Subject: Dresden Station Unit 2
SEP Topic VI-7.C.1
Docket No. 50-237

IPSAR Section 4.21.1
Breaker Adequacy

125V DC SYSTEM SINGLE LINE

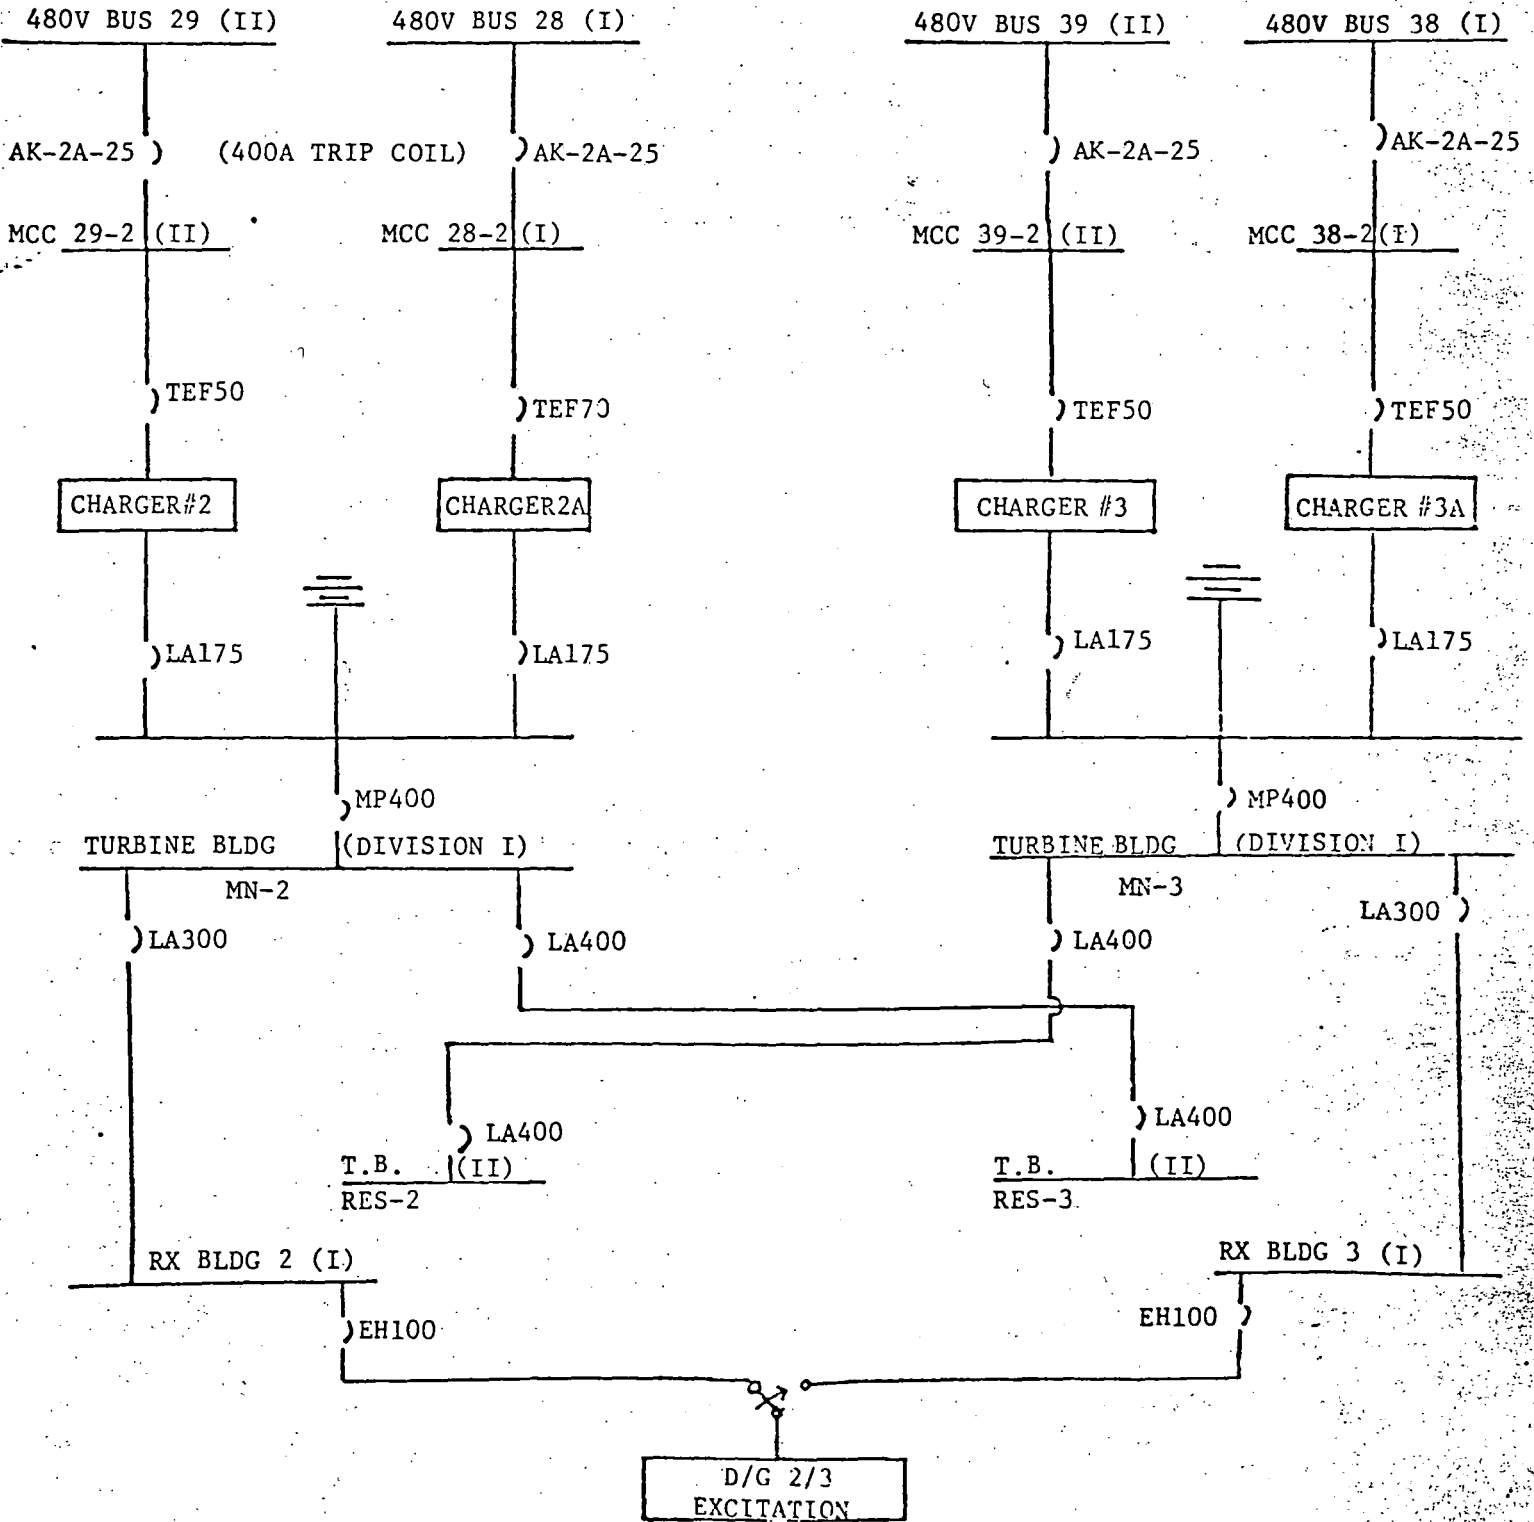
Division I motor control centers (MCCs) and Division II MCCs can be subjected to common faults and transients that may occur on the dc system if their respective battery charger output breakers are both closed. Individual manually operated circuit breakers connect the outputs of each of the chargers to the single battery and dc loads. The manual aspect of the design meets review guidelines defined in position D.4.d of Regulatory Guide 1.6. However, the two ac breakers and two dc breakers per charger plus the isolation characteristics of each charger provide isolation and separation of ac power sources. Thus, there is not direct connection of ac power systems. It is the staff's position that the licensee verify the adequacy of the protective relaying so that operator error will not result in a loss of redundant ac sources.

The design of the 125-V dc system provides for the automatic transfer of the control and instrument power for the diesel generator (DG 2/3) from the Unit 2, Division I, 125-V dc distribution panel to the Unit 3, Division I, 125-V dc distribution panel. The Unit 3 battery/battery-charger combination is the power source for both Unit 2, Division II, and Unit 3, Division I. Therefore, the diesel generator control and instrument loads are automatically transferred between redundant divisions. This is a deviation from current review criteria.

As shown in Exhibit 1, each unit's 125V battery bus has two chargers connected to it. Only one of the chargers is required at a time. Therefore, only one of the two charger breakers needs to be closed.

As shown in Exhibit 1, the diesel generator 2/3 excitation cabinet can be fed from either the Unit 2 reactor building distribution panel or from the Unit 3 reactor building panel. The Unit 2 reactor panel is part of Division I of Unit 2. The dc source for the Unit 3 reactor panel also feeds Division II of Unit 2. Therefore, whenever excitation cabinet load is automatically transferred from the Unit 2 reactor panel to the Unit 3 panel, this load is connected to a power supply which is feeding Division II of Unit 2. The NRC has questioned whether a fault downstream of the diesel generator 2/3 excitation cabinet transfer switch could cause the loss of redundant dc division of Unit 2.

250V DC SYSTEM SINGLE LINE

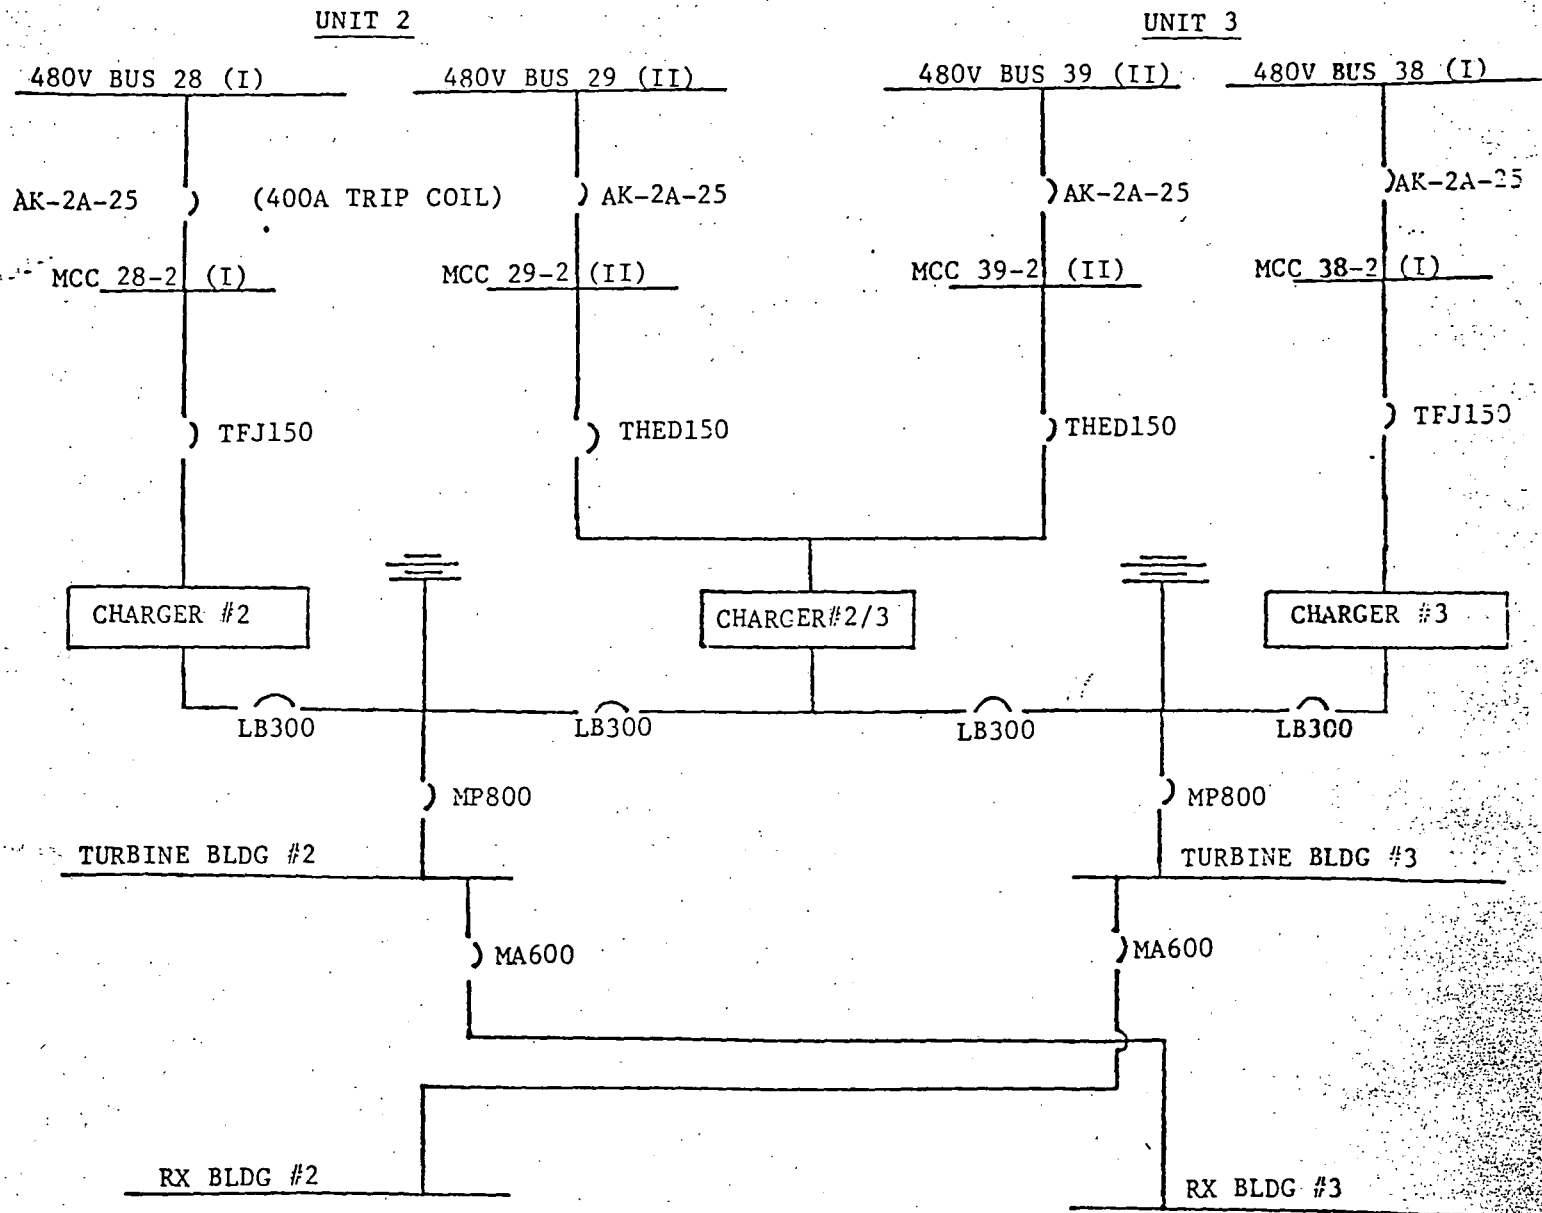
The standby 250-V battery charger (a Division I system) is supplied power from either the Unit 3 or Unit 2, Division II power source through a key-interlock switch. When power is supplied from Division II of Unit 3 to the Unit 2 battery, there is sharing between Units 2 and 3. This sharing is covered by SEP Topic VI-10.B. When power is supplied from Division II of Unit 2 to the Unit 2 battery, there is an interconnection between redundant divisions. It is the staff's position that the licensee verify the adequacy of the protective relaying so that a fault in one dc system would not be transferred to the other dc system.

As shown in Exhibit 2, the 250V standby charger 2/3 can be fed from either a Unit 2, Division II or a Unit 3, Division II ac MCC. Battery charger 2 is fed from Division I of Unit 2.

When the swing charger is used to feed the Unit 2 turbine building 250V dc MCC and is itself fed from the Unit 2, Division II ac MCC, and the breaker for battery charger 2 is closed, then both redundant ac divisions would be connected to the same 250V dc MCC. The NRC has questioned whether a fault on the dc MCC under this condition could cause a loss of both redundant ac divisions of Unit 2.

BREAKER COORDINATION FOR
DIESEL GENERATOR 2/3
EXCITATION CABINET FEED
FROM UNIT 2, HSS

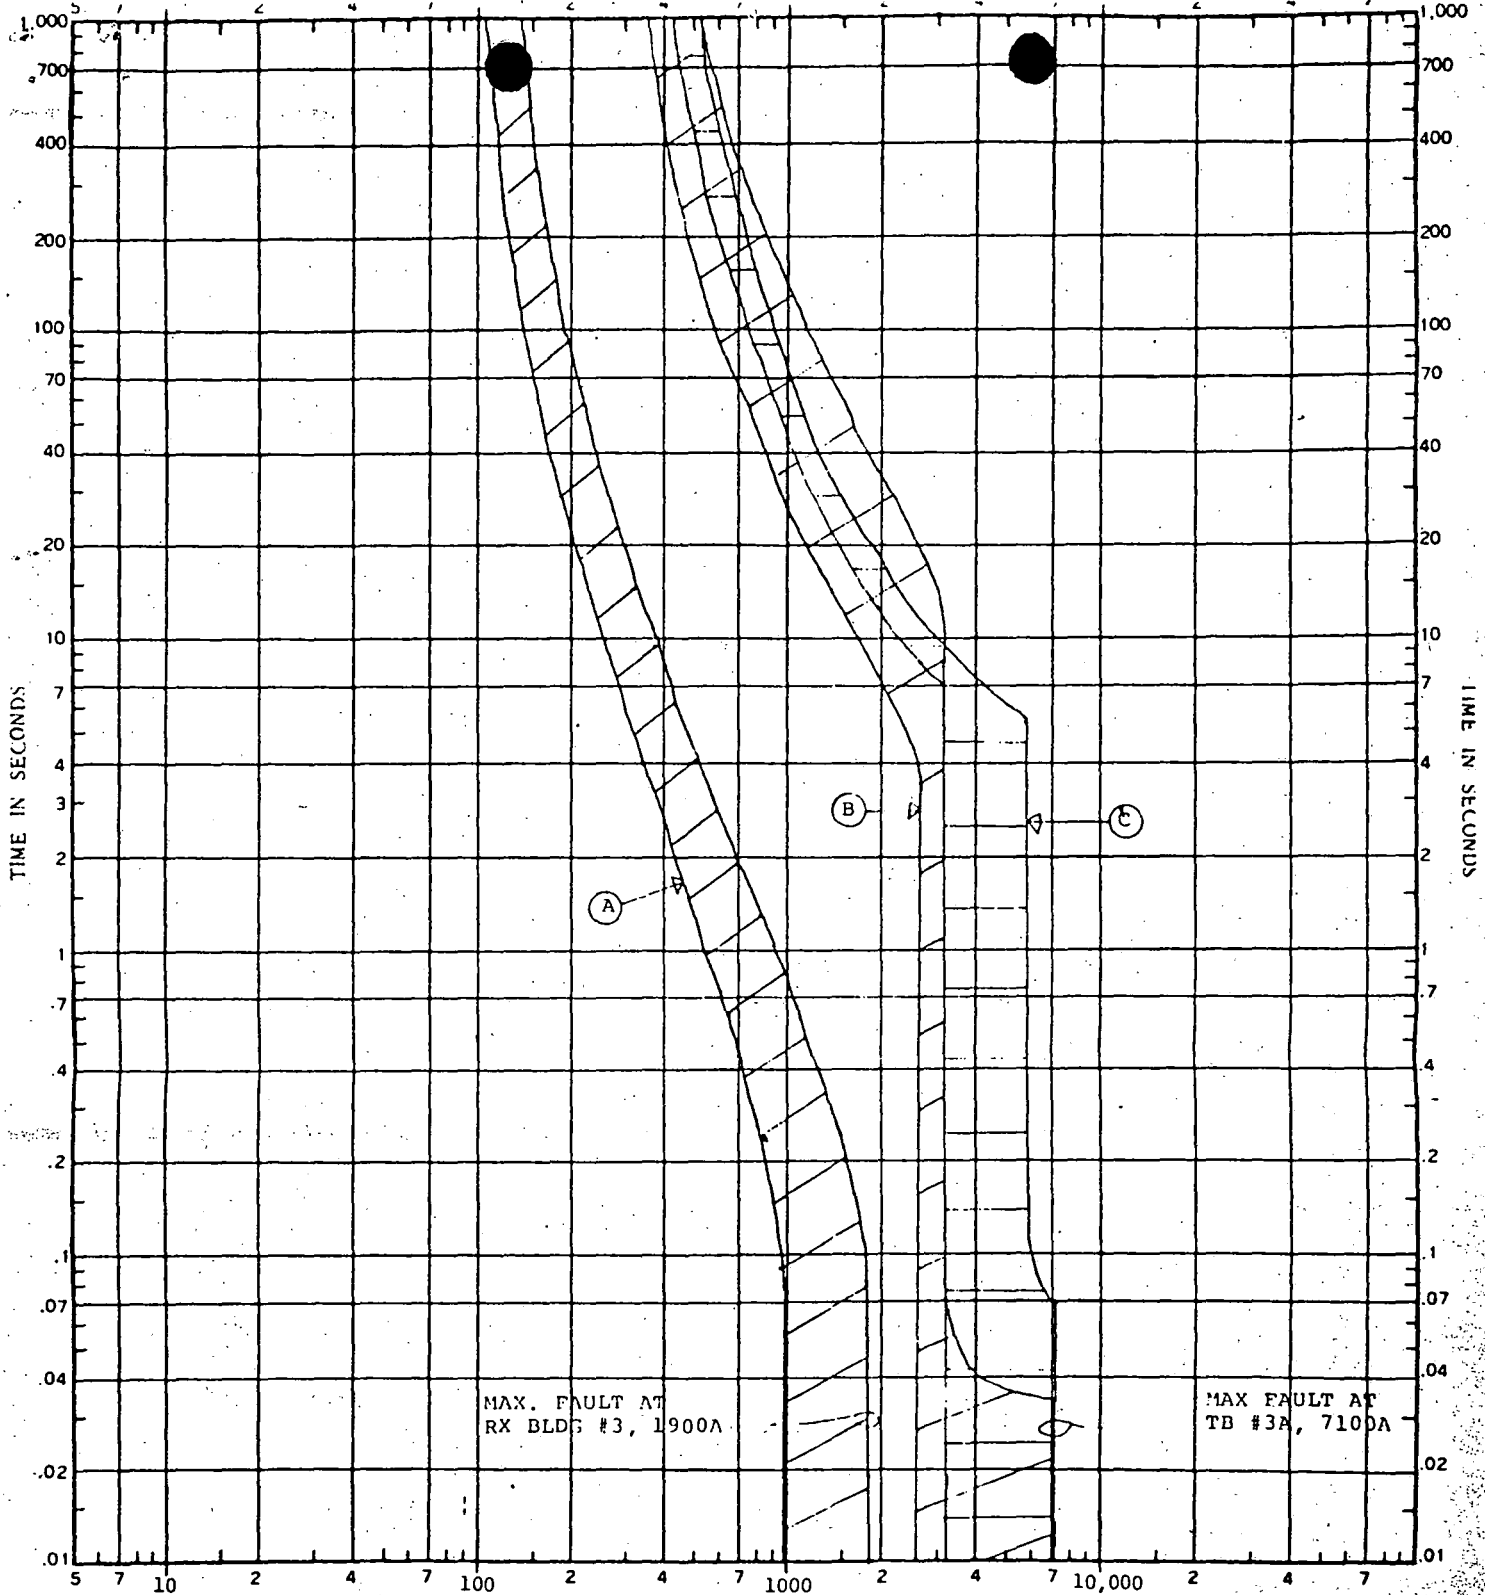
It is the staff's position that the licensee verify the adequacy of the protective relaying so that a fault in the DG 2/3 control system will not result in a loss of redundant dc sources.

As indicated by the breaker coordination curves shown in Exhibits 4 and 5, a fault on the feed to the diesel generator 2/3 excitation cabinet will not cause an instantaneous trip of the MP400 main breaker feeding the turbine building Division I bus. The maximum fault level at the reactor building Unit 2 panel is below 1500A, whereas the minimum instantaneous pickup of the MP400 is about 3200A. The cable resistance used to calculate the maximum fault current are indicated in Exhibit 6.

If the EH100 breaker fails to open, the load will be transferred by the undervoltage sensed to the other source after about 1 second. Therefore, the long time portion of the MP400 breaker will not operate. A single failure will, therefore, not cause the loss of redundant dc divisions.
